Docket Item #9
BAR CASE #2004-0068

BAR Meeting
July 21, 2004

ISSUE: Alterations and addition
APPLICANT: Steve Edson and Kelly Worthington
LOCATION: 510 North Columbus Street
ZONE: RM/Residential

Figure 1 - Front Elevation

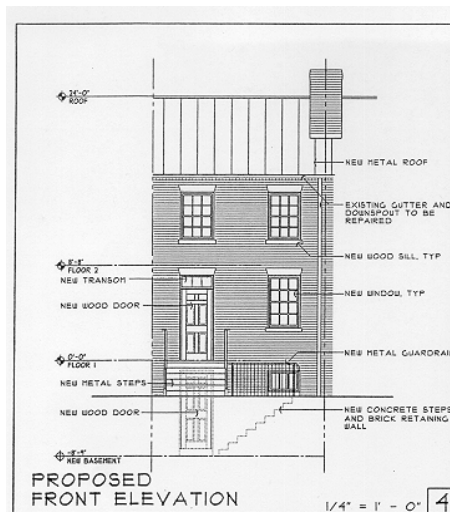
Staff has no objections to the alterations proposed for the front facade. Staff believes that they are appropriate and will improve the historic appearance of the house. Staff can support simulated divided lights in this instance because they will be replacing the existing inappropriate non-historic windows and will not be readily accessible to the public as the house is set back from the sidewalk by over 8'. The materials provided by the applicant were not entirely clear as to which of the divided light options would be included. The exterior bars should be wood and the window should also include the internal spacer bar and interior bar.

1. Approval of the alterations to the front of the house; and,
2. Deferral for restudy of the size of the proposed addition.

Figure 2 - Rear Elevation

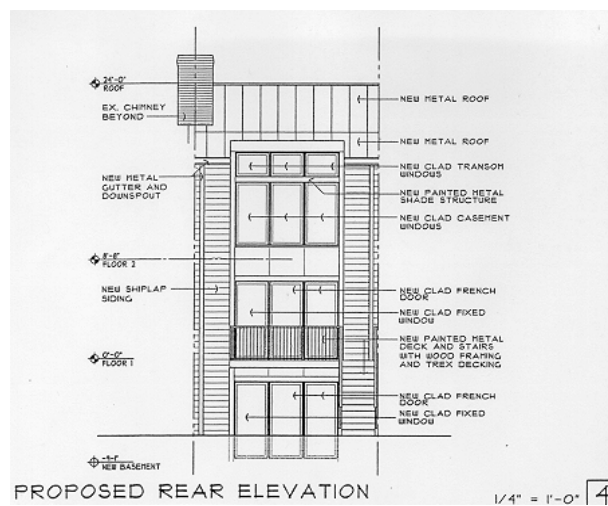
In general, Staff is supportive of a rear addition to this rowhouse and believes that the design vocabulary of the rear elevation is appropriate because the front facade and the rear elevation cannot be seen together. The design of the addition is clearly differentiated from the historic main block of the house, an approach recommended by the *Design Guidelines (Residential Additions - Page 5)*. While the Board generally prefers wood windows, Staff does not object to the proposed use of Ultrex for the rear windows. These windows will be well removed from the public access and will be on a clearly modern structure. The Board has adopted the following policy with respect to fiber cement:

On the other hand, Staff is quite troubled by the overall size of the addition. As currently proposed, the addition represents an increase in the size of the existing house of approximately 77%. In the opinion of Staff, the addition is so large that it overwhelms the existing relatively small historic house. In addition, the 21'6" long and three story high sidewalls will overwhelm the houses to the north and south. The *Design Guidelines* note that "[g]enerally, additions should not overwhelm the existing structure or neighboring buildings." (Residential Additions - Page 6). In general practice, the Board has striven to keep additions to a size that is approximately no larger than the historic main block so that they do not, in fact, overwhelm an existing historic building. Several of the existing additions in the row are of similar or even longer length. However, all were approved over a decade ago. On a more practical note, Staff has concerns about the fact that the proposed addition will leave only 801.55 square foot of open space when 800 square feet are required. This leaves virtually no margin for error in the construction

process. Based upon all the above, Staff believes that the application should be deferred for restudy for an addition that is more appropriate to the size of the existing house.

1. That the fiber cement siding is smooth and the nails do not show in the installation; and,
2. That the following statement appears in the General Notes of the site plan so that on-site contractors are aware of the requirement:
